Briar Vista ES
Change Order No. 04 - Breakdown

Briar Vista Elementary School Major System Replacement
RFP 23-752-017
Centennial No: 73150-0148

Bulletin-R1 Narrative

POTENTIAL CHANGE ORDER (PCO) REQUEST

JOB 21309.0000
DATE 04/11/2024
SHEET
A08-2

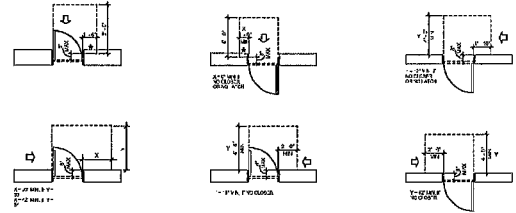
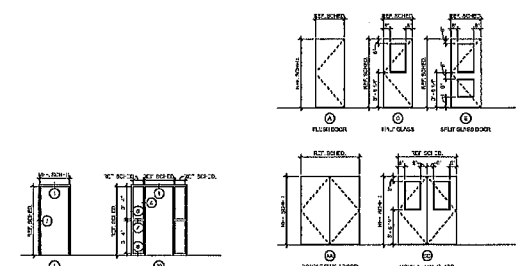
A08-21-

- New exterior storefront doors 100A, 100B
- New interior storefront doors 100D, 100F
- New storefront door 101A
- New storefront door 121A
